## OPTIONAL SERVICE BULLETIN

NO. OSB40-031/1  
NO. OSBD4-034/1  
NO. OSBF4-006

Installation of Winter Baffle in Wing Fresh Air Inlet.

### „WINTER BAFFLE FRESH AIR INLET“

DA4-5310-00-00x01

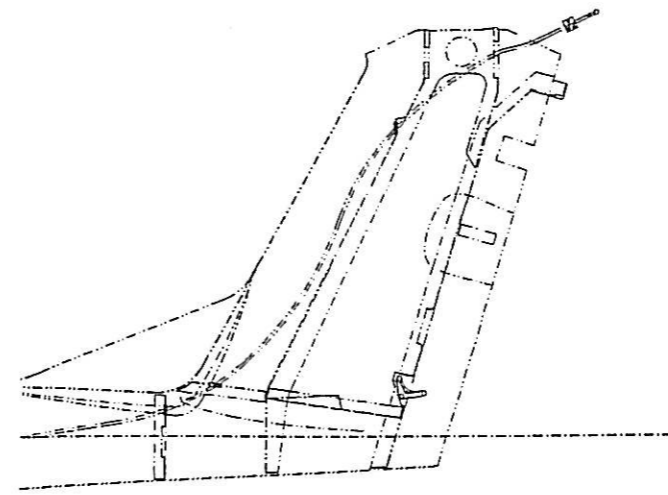
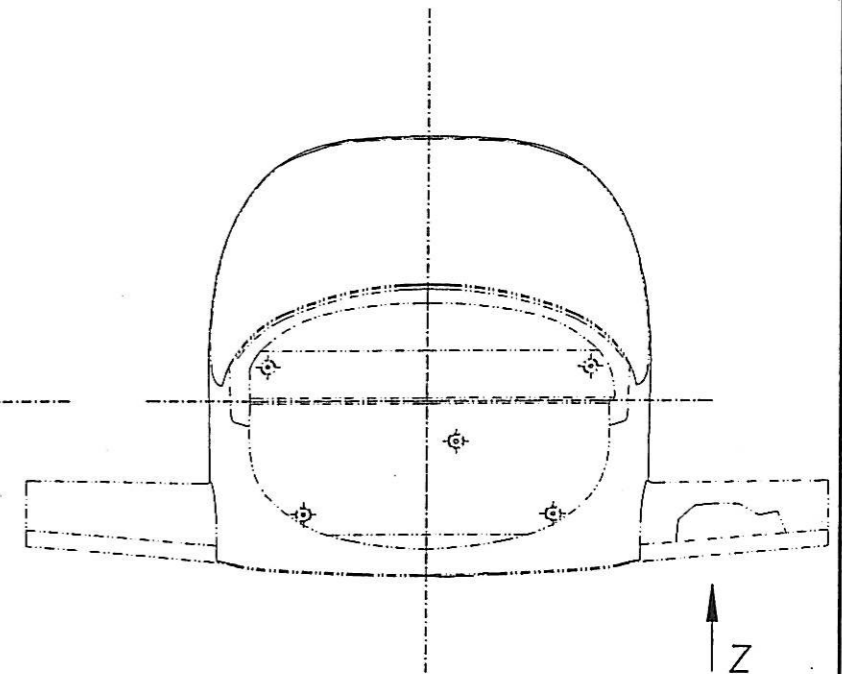
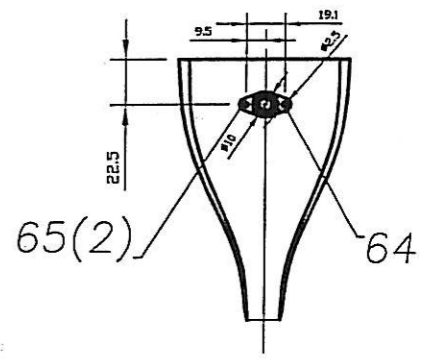
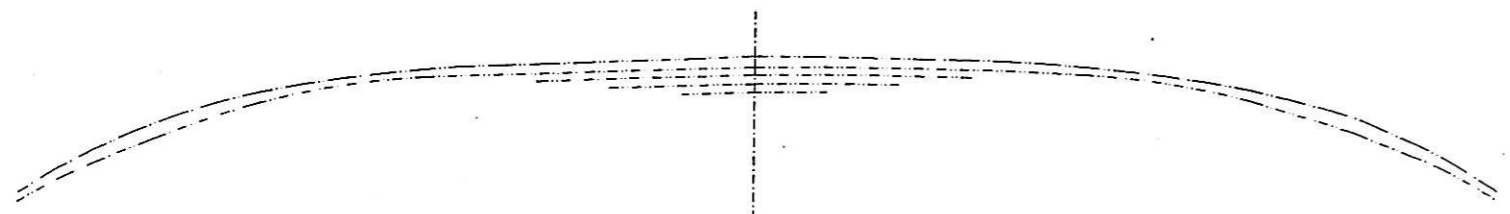
1	Mark Positions for holes according to Dwg.No. D41-5310-00-00x01
2	Drill 2 • 2.4mm holes and 1 • 10mm hole on marked positions.
3	Install Camloc receptacle, part number 212-12N, with rivets, part number CCR244SS-3-04 (or DIN 7337-B 2,4 x 8,5).
4	Clean working area and check for foreign objects
5	Install Winter Baffle into Fresh air inlet
6	Check for adequate clearances and proper operation of Winter Baffle
